PLAN COMMISSION STAFF REPORT

Agenda Item: PC Docket No. 23-015

Application: **Development Plan**

Summary: Matt Kimmel/Centennial Village LLC, is requesting approval of a development plan of Building M within Centennial Village Planned Unit Development

CENTENNIAL VILLAGE -
LOT 9 - BUILDING "M"
Site Plan

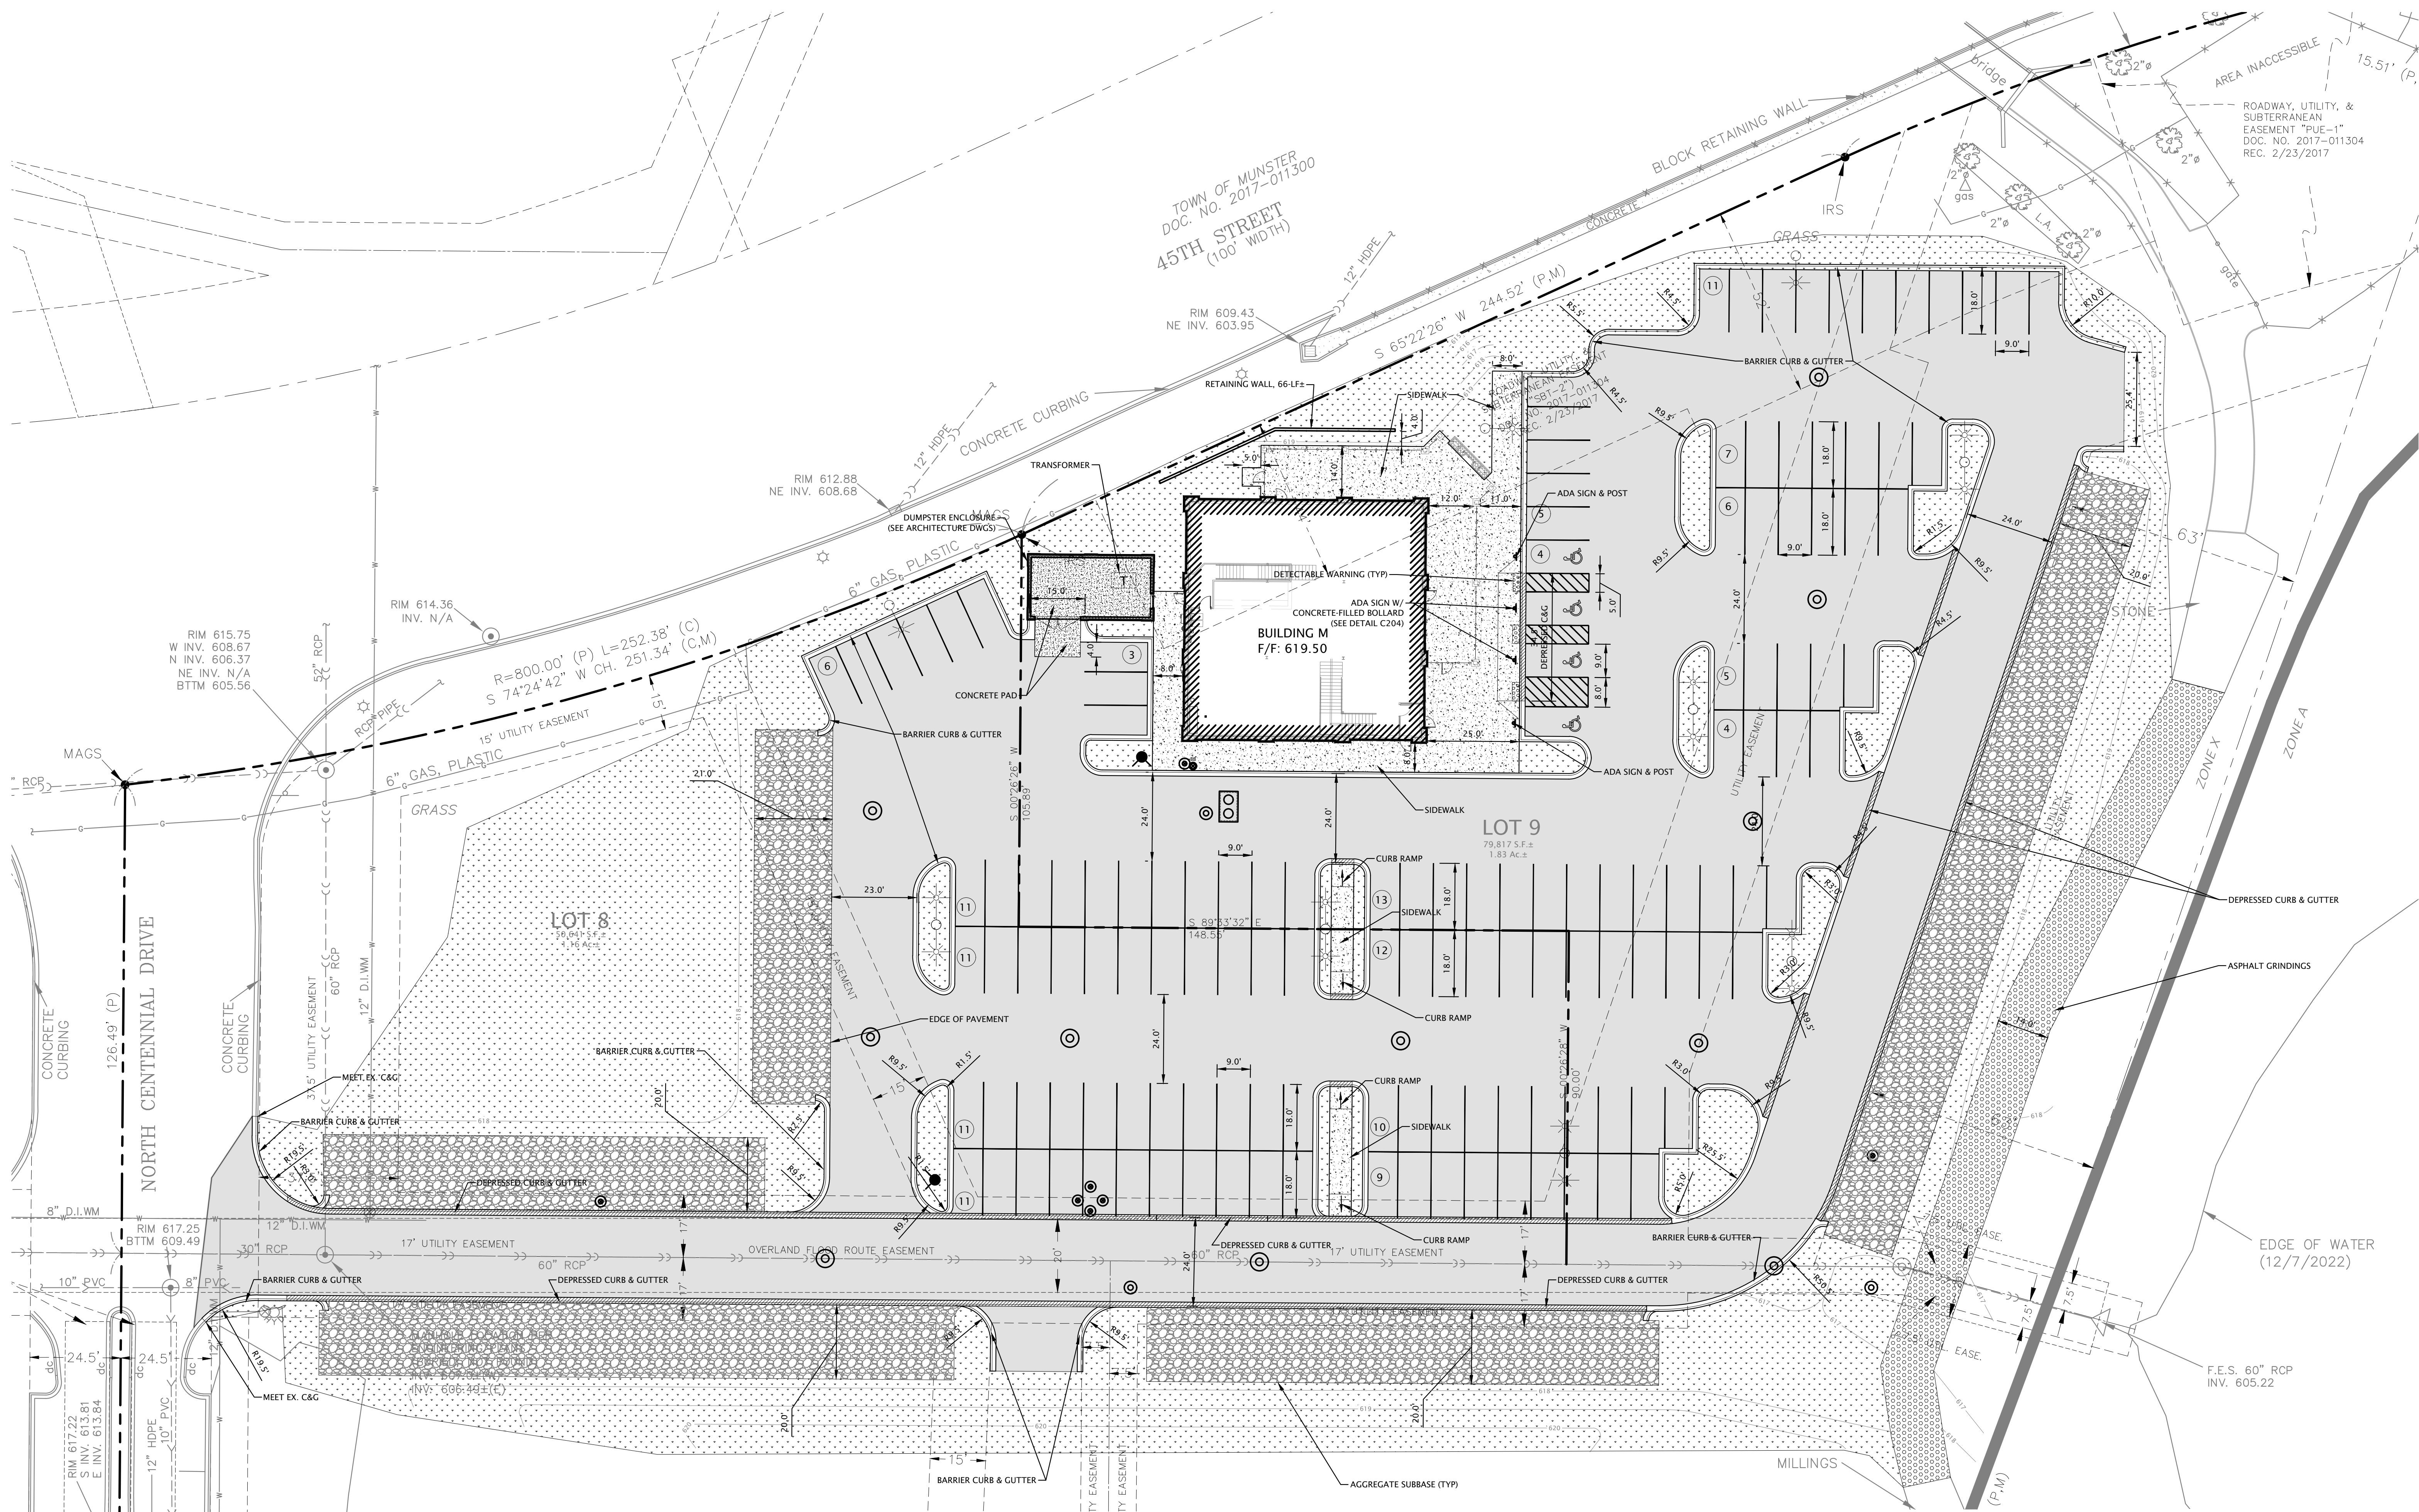
With Building M moving to the west, it has been pulled off of the Pensey Greenway. It also appears that the sidewalk along the south side of 45th Street has not been included on the submitted drawings. Staff would like to see the site plan modified to show how pedestrians using Building M would navigate to Building I and the rest of the Centennial Village pedestrian network without having to get in a vehicle or walk through grass.

Per the Centennial Village PUD Design Standards, site furnishings and fixtures will be incorporated into the final site design of all buildings. At a minimum, the locations of bicycle racks, decorative trash receptacles, pedestrian benches, and decorative plant containers must be shown on the site plan.

1. *Approval of PC Docket No. 23-013 and 23-014 and any conditions that are part of those approvals.*
2. *The addition of a sidewalk on the south side of 46th Street as shown in the Centennial Village Concept Plan.*

3. *The sidewalk network around Building M will be modified to connect to the future Building I and the rest of the Centennial Village pedestrian network.*

6. *The locations of site furnishings and fixtures will be shown on the site plan (including bicycle racks, decorative trash receptacles, pedestrian benches, and decorative plant containers).*

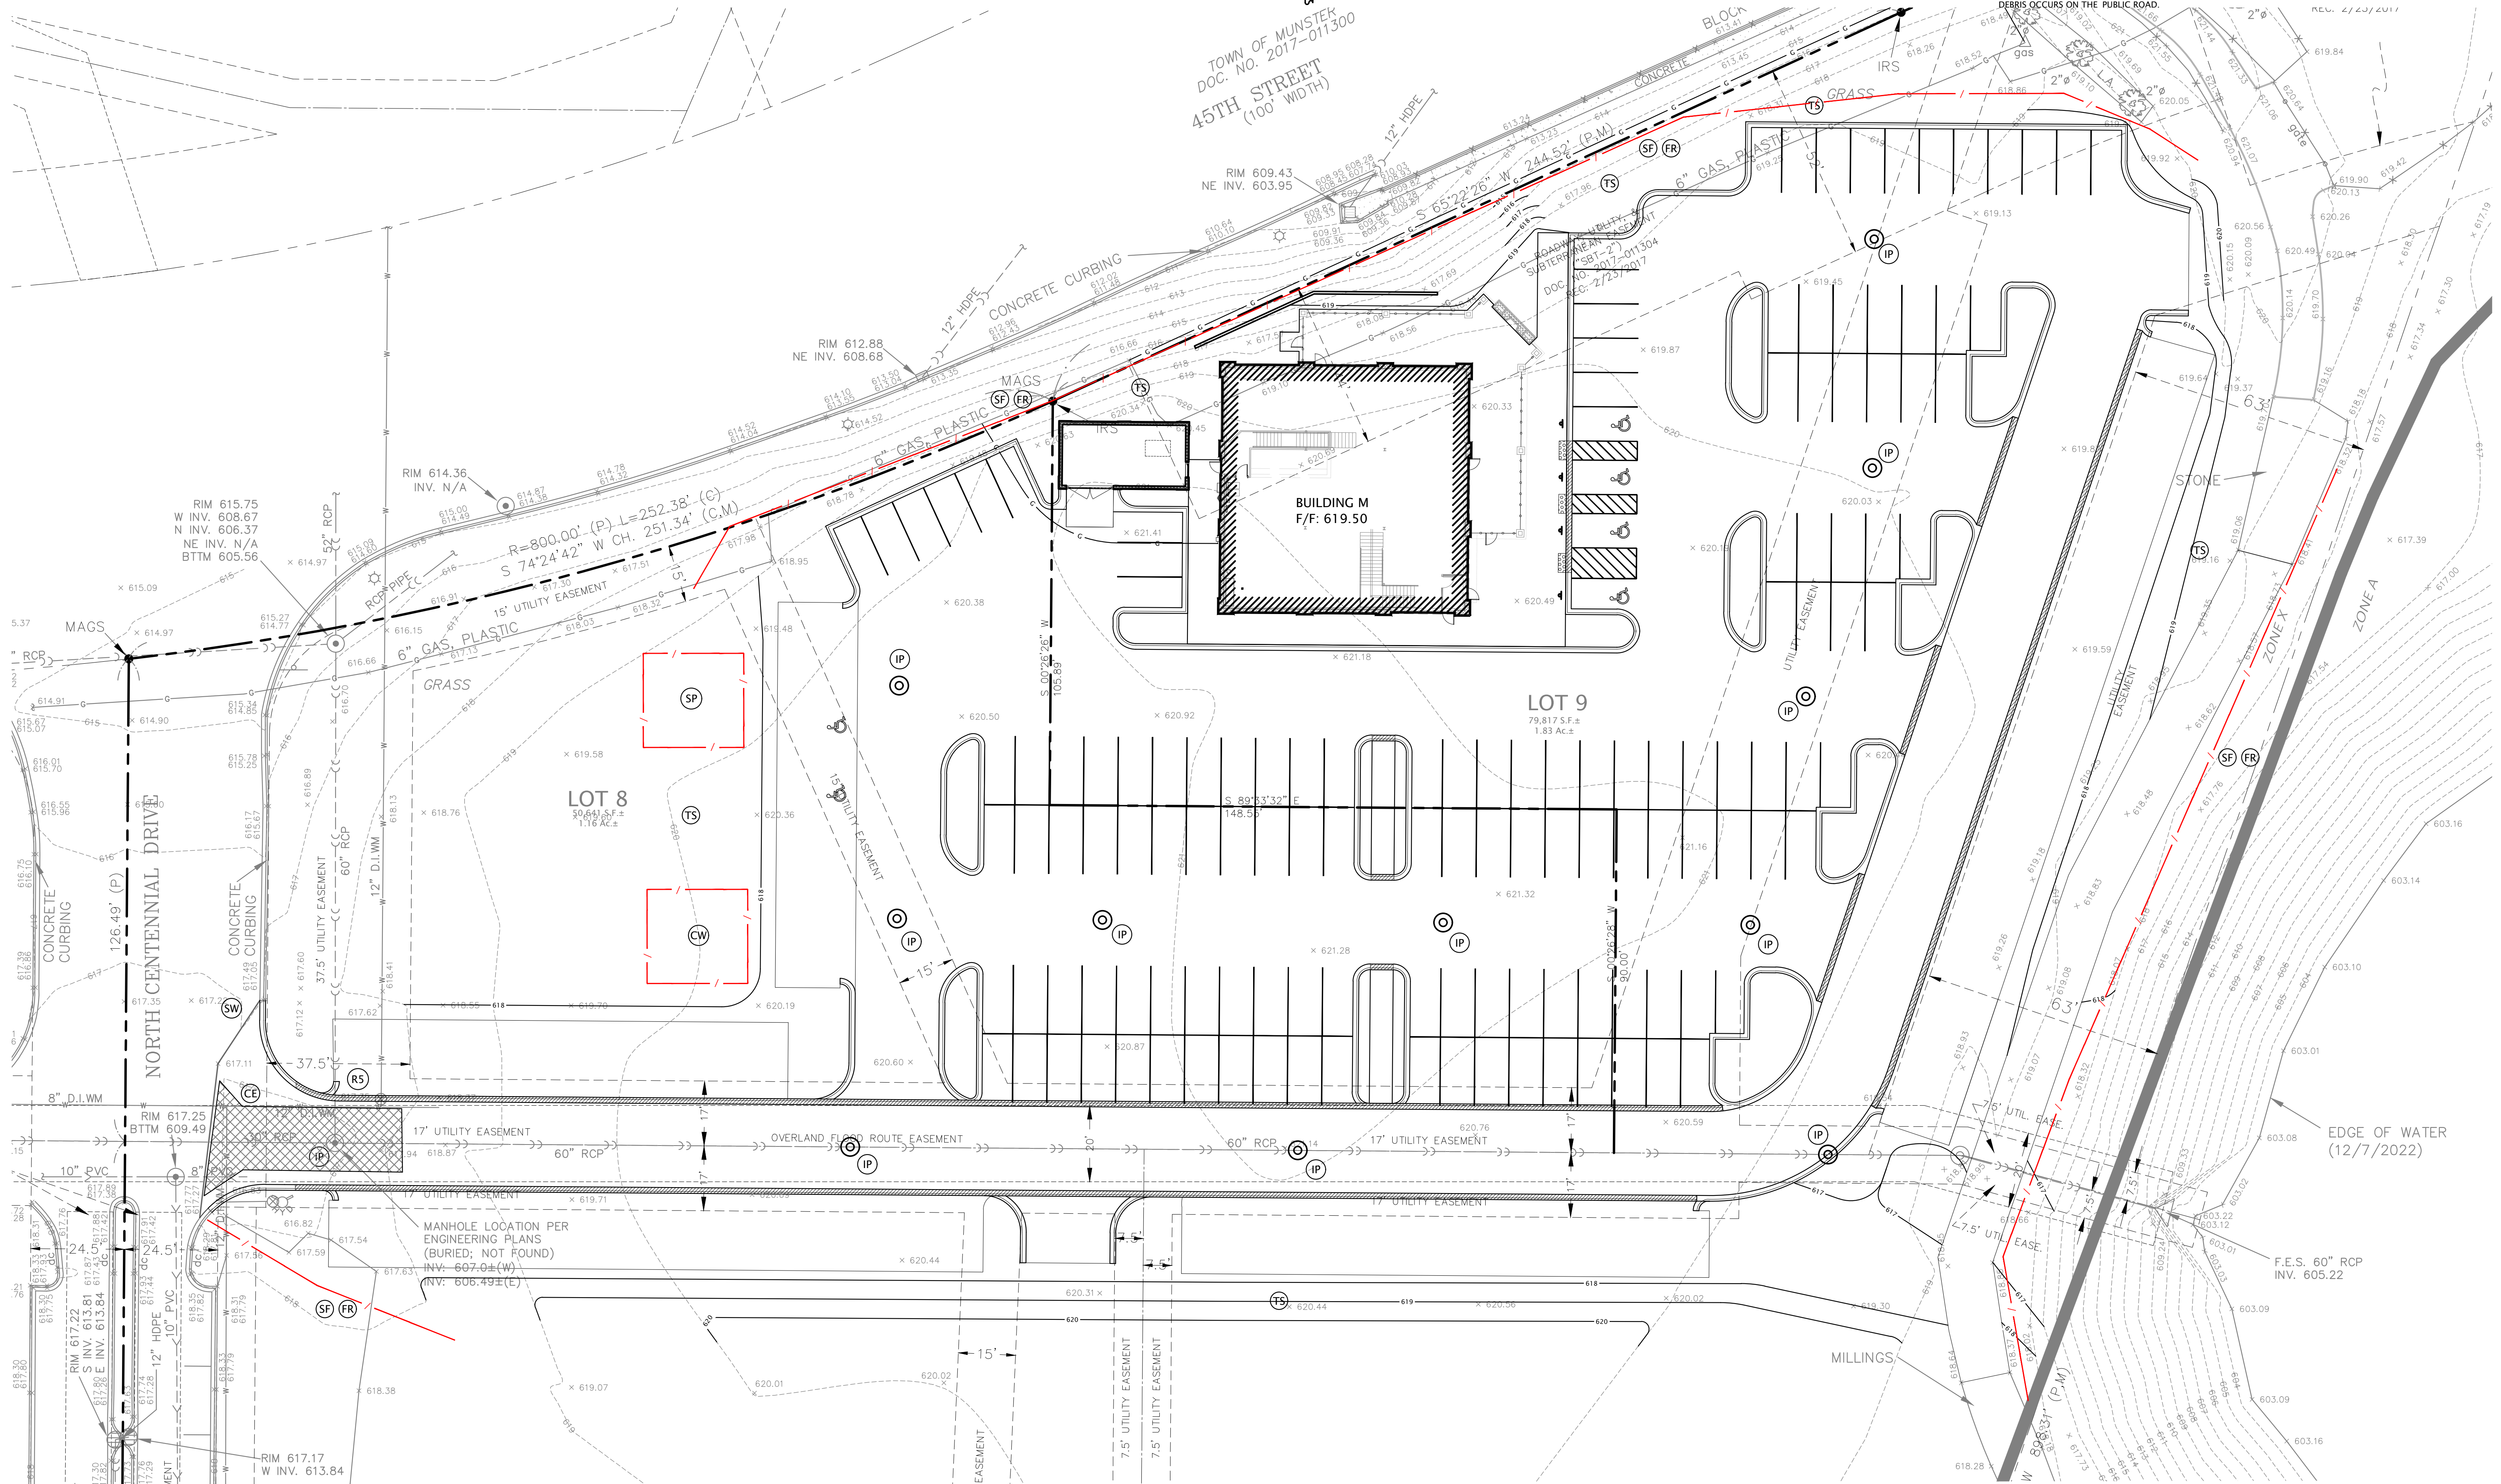
Maintenance of the hydrodynamic separator is not included on the Post-Construction Stormwater Management Plan on Sheet C-301. This addition should be made to the drawing set.

7. *Maintenance of the hydrodynamic separator in the Post-Construction Stormwater Management Plan.*
